UNITED STATES PATENT AND TRADEMARK OFFICE

APPLICATION NO.	FILING DATE	FIRST NAMED INVENTOR	ATTORNEY DOCKET NO.	CONFIRMATION NO.
09/741,739	12/21/2000	Bo Hakansson	1274	5587

Office Action Summary

- 1) ☒ Responsive to communication(s) filed on 14 April 2003.
- 2a) ☒ This action is **FINAL**. 2b) ☐ This action is non-final.
- 3) ☐ Since this application is in condition for allowance except for formal matters, prosecution as to the merits is closed in accordance with the practice under *Ex parte Quayle*, 1935 C.D. 11, 453 O.G. 213.

FIG. 1

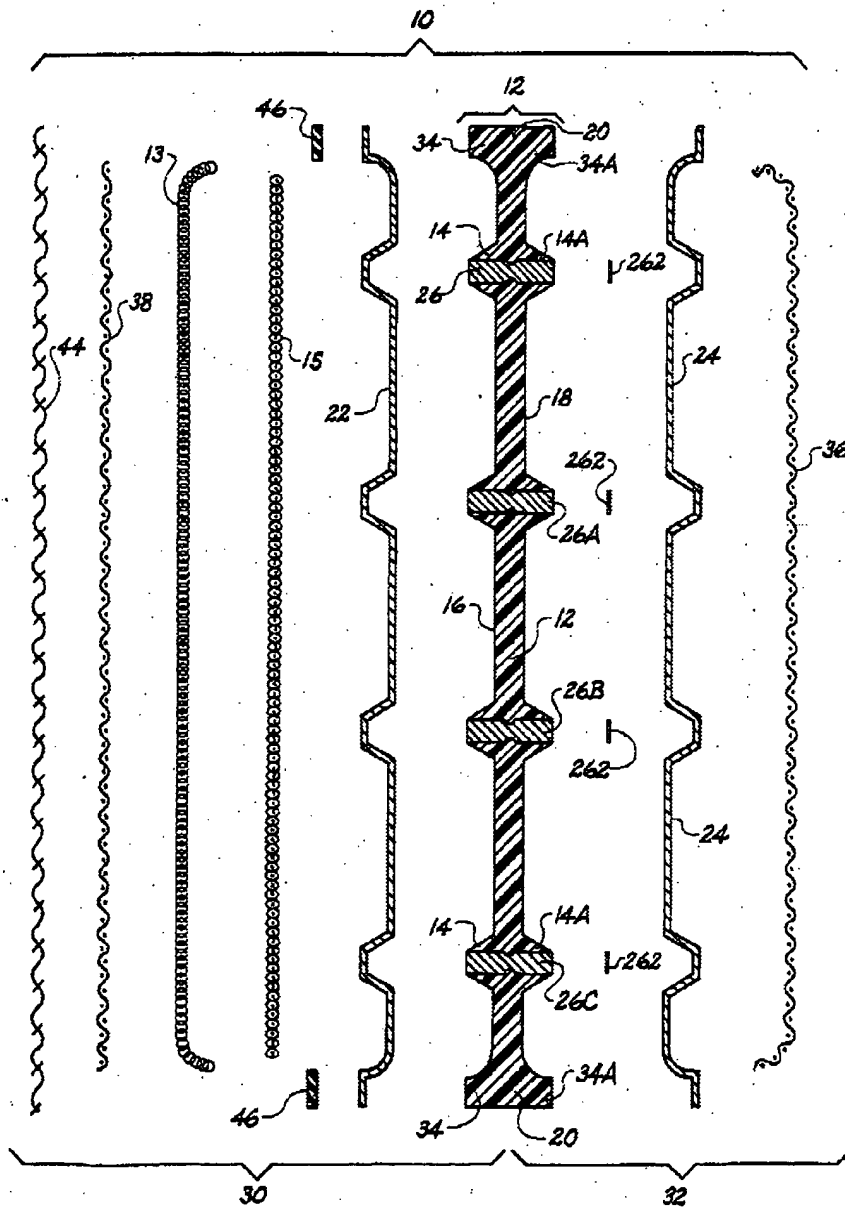
Pimlott et al. disclose a construction for an electrochemical cell. The construction includes a first metallic layer (36), an anode which is preferably a metal, such as tantalum, tungsten, columbium, zirconium, molybdenum, or titanium, with Ti being most preferred. (Column 6, lines 39-46.) A second layer cathode (38), which is made of a metal such as iron, nickel, lead, molybdenum, or cobalt. (Column 6, lines 54-66.) Reference numeral 13 is a layer described as a "mattress" and is a mesh for venting gases. (Column 7, lines 13-20 and US Patent 4,444,632 column 4, lines 19-27

and 66-68.) The third layer disclosed by Pimlott et al. is the catholyte cover (22) which is preferably made from iron, steel, stainless steel, nickel, lead, molybdenum or cobalt. (Column 5, line 56-column 6, line 2.) With regards to claim 36, the third layer (reference 22) is relatively non-porous and will have a lower hydrogen permeability than the second layer (reference 38) which is intended to be permeable to hydrogen. (Column 7, lines 24-32.) A fourth layer is the anolyte cover, reference numeral 24.

With regards to claim 33, a preferred embodiment of mattress 13 includes intermeshed wound metallic spirals forming channels. The spirals have diameters 5 to

10 times the diameter of the wires used. (See US Patent 4,444,632 column 4, lines 53-62.) Preferred diameters for the wires are between 0.05 and 0.5 millimeters. (US Patent 4,444,632 column 12, lines 38-40.) Therefore, diameters of the channels in the mattress used in the Pimlott et al. invention are in the range of about 0.25 mm and 5 mm or 250 microns to 5,000 microns.

Applicant asserts Pimlott does not disclose a mesh joined between a first and second metallic layer. However, Pimlott discloses in Fig. 1 a layer (13) disposed between layers (36) and (38). Both (36) and (38) are metallic. Reference number 13 is described by Pimlott as a "mattress". This structure, which is used by Pimlott to establish electrical contact between the cathode (38) and current collector (15) is taught as having the same type of structure as compressible, pliable and spring like electrode element described by deNora. (See deNora, Fig. 4 and column 11, lines 9-22.) The element shown by Pimlott as (13) is described by deNora as including mesh.
